**BEFORE THE
PENNSYLVANIA PUBLIC UTILITY COMMISSION**

Implementation of the Alternative Energy :
Portfolio Standards Act of 2004: Standards :
for the Participation of Demand Side : **Docket No. M-00051865**
Management Resources – Technical :
Reference Manual 2011 Update :

**COMMENTS OF PECO ENERGY COMPANY ON THE
PROPOSED UPDATE TO THE TECHNICAL REFERENCE MANUAL**

Figure 1 Comparison of CFL Markets.

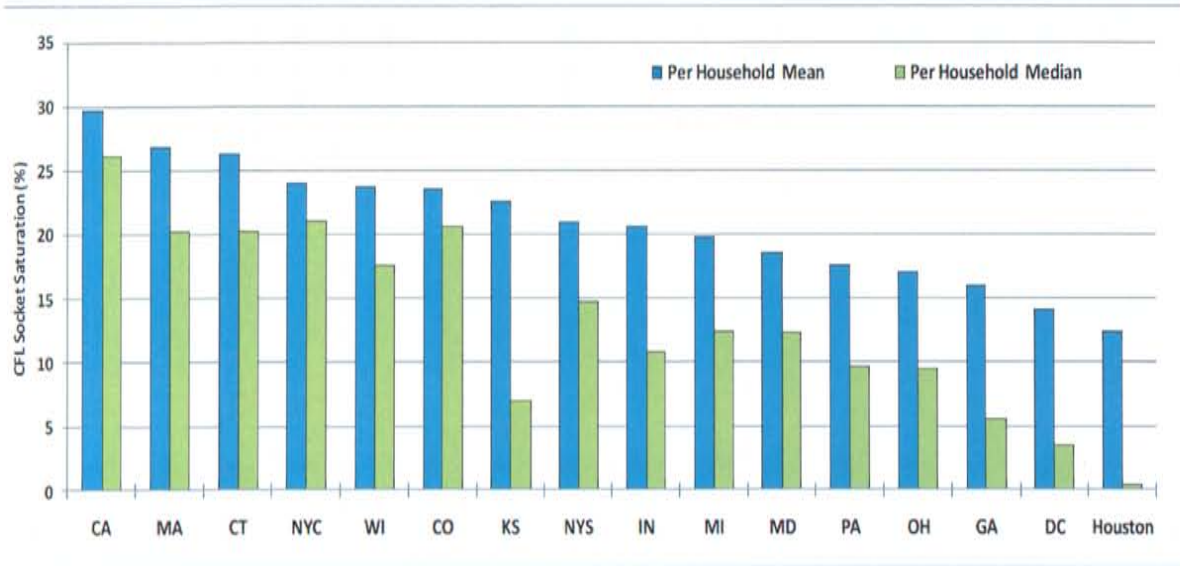
The median CFL saturation in California households is 2.5 times higher than in Pennsylvania. *See* Figure 1. As CFLs become more commonplace, and their use more widespread, they tend to have lower HOU, on average, because the initial CFL bulb installations are in the most favorable locations in terms of bulb usage and payback. Homeowners will first look to displace inefficient incandescent bulbs in high usage locations such as kitchens, dining rooms, living rooms and outside. Later on, as they gain more experience and become comfortable with the CFL color rendition and light quality, homeowners install CFLs in lower-use locations, such as bathrooms and bedrooms. California has, in fact, experienced a significant decline in average HOU in only the past few years. *See* Table 1.
